22. NOISE AND VIBRATION

This Chapter responds to issues raised in relation to the Noise and Vibration impact assessment undertaken for the Traveston Crossing Dam EIS.

Figure 22-2 Typical Sound Pressure Levels for Everyday Noise Sources

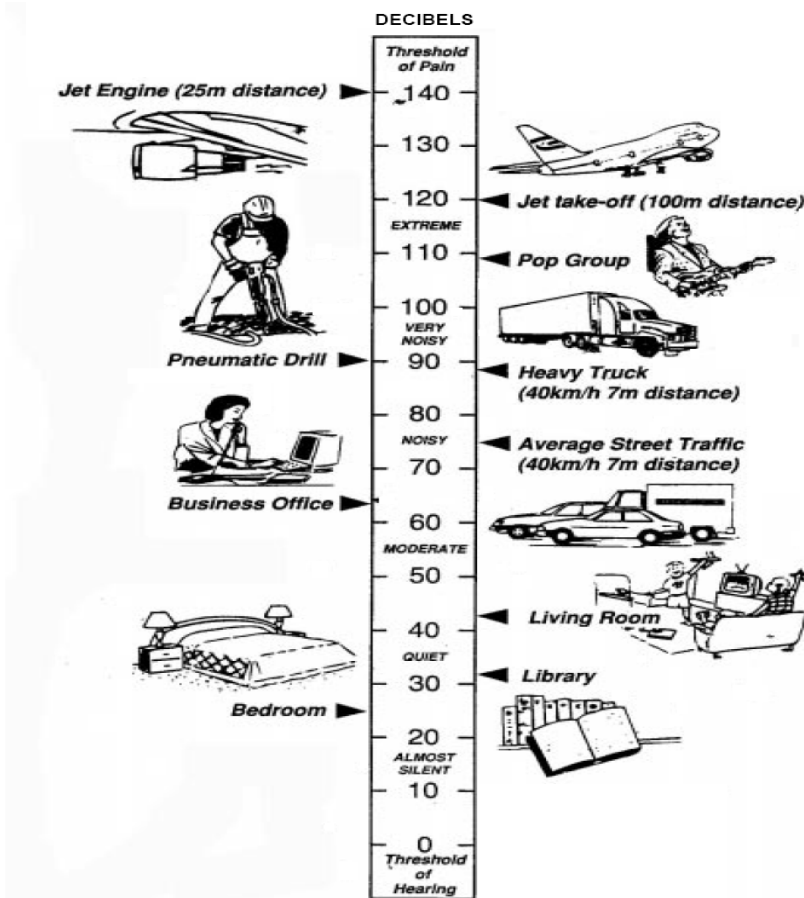
One submission raised the issue that the relocation of the Gympie – Brooloo Road (Mary Valley Road) would negatively impact their property as a result of increased noise during construction and operation particularly due to the geography of the valley.

Section 11.2.8 of the EIS discusses the predicted noise impacts associated with the relocation of the Gympie – Brooloo Road (Mary Valley Road). The distance between the Gympie – Brooloo Road (Mary Valley Road) and 92 Frayne Road (as indicated as a sensitive receiver in the submission) is over 300 m. The projected traffic volume on Gympie – Brooloo Road (Mary Valley Road) is 2,840 vehicles per day in 2021. This is equivalent to approximately 2 vehicles per minute.

Given the large separation distance and low traffic volume, the traffic noise impact from the Gympie – Brooloo Road (Mary Valley Road) would be relatively minor. The predicted traffic noise level, LA10(18h hour), from the Gympie – Brooloo Road (Mary Valley Road) at the residence is approximately LA10(18h hour) 45dB(A). This is similar to the noise level of a typical living room (see **Figure 22-2**).
